Staff Report for Administrative Approval

Weber County Planning Division

Application Request: Approval of a design review request for a commercial building in the Blacksmith Village. The commercial building will be known as the Crane building in the Blacksmith Village

File Number: DR2019-02

Exhibit B-Approved Architectural Renderings

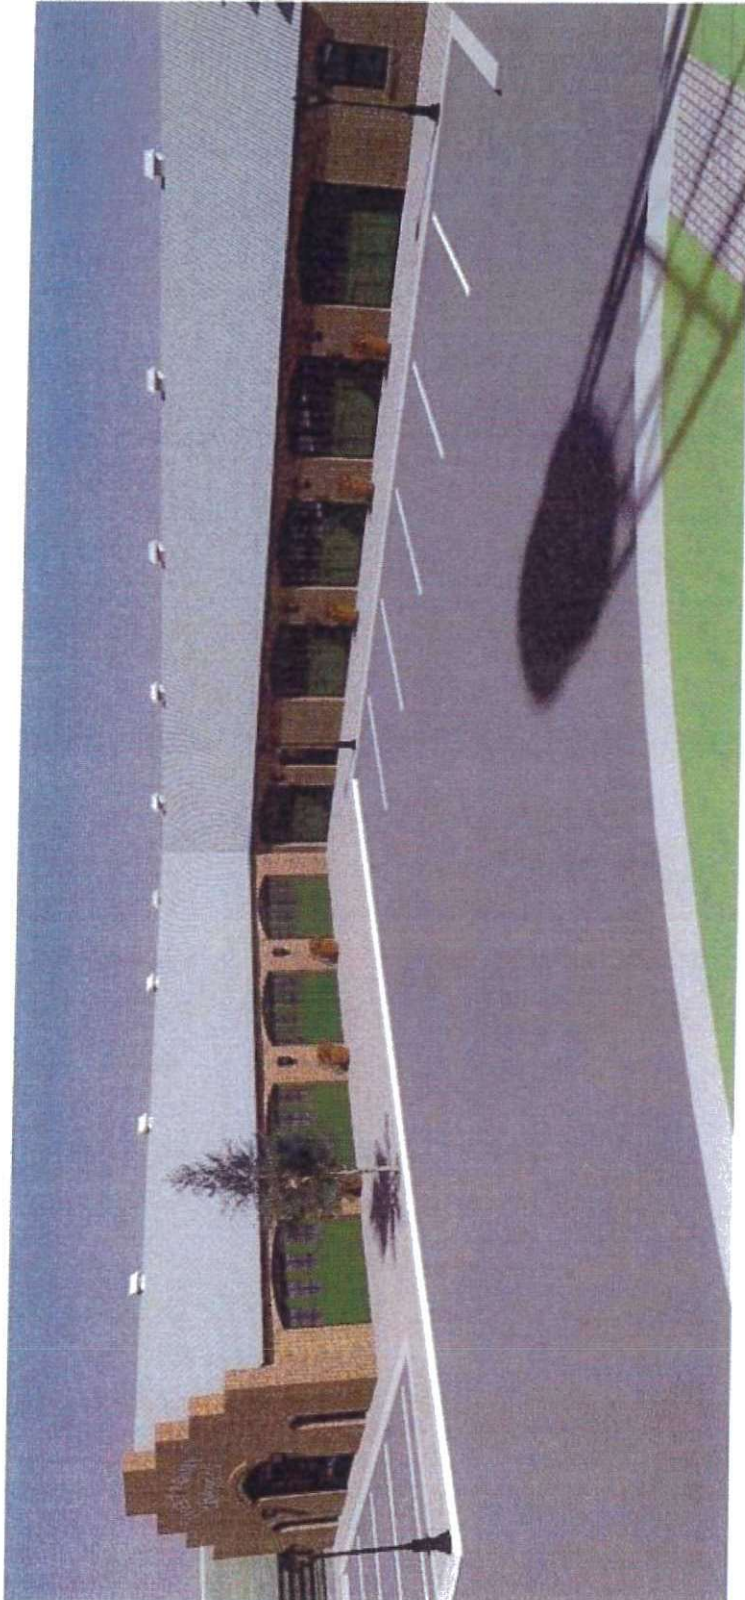
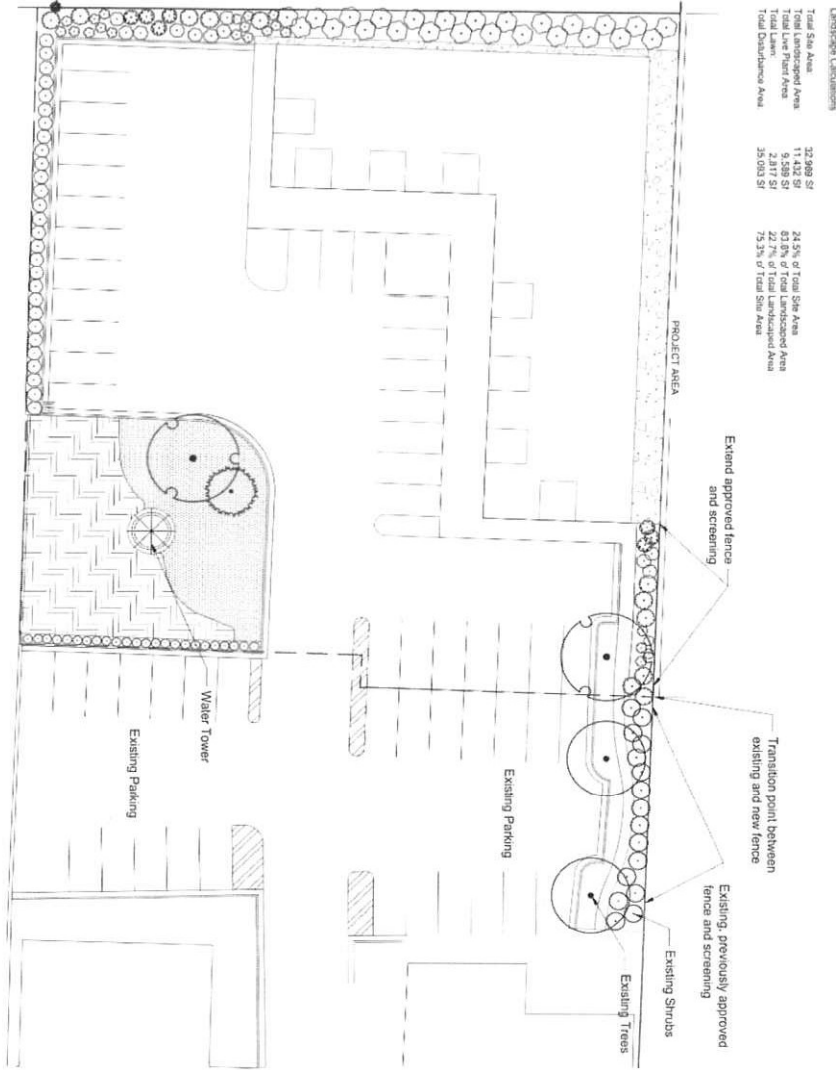
2) *Considerations relating to outdoor advertising.* The developer has provided architectural renderings for the building in the CV-2 Zone that include the location, color, and size of the proposed structure (see Exhibit B). The lighting associated with the building provides for dark sky preservation by ensuring that the site is in conformance with the standards of the LUC §108-16 pertaining to the Ogden Valley Lighting. The developer will be required to apply for a design review for any signage to ensure that the proposed signs do not exceed five percent of each unit as allowed in the LUC §110-2-5 as a design review amendment. All lighting standards will be verified during the building permit process. A condition has been made part of the Planning Division's recommendations to ensure that these standards are met.

1. Actual dimensions for all signage will be provided for review and approval prior to the issuance of a land use permit to ensure that the proposed sign does not exceed five percent of the unit.
2. All lighting will be dark sky compliant and the standards will be verified during the building permit process.
3. If the landscaping is not in place prior to the applicant receiving a certificate of occupancy, a bond for the remaining amount of the landscaping will need to be deposited with Weber County.
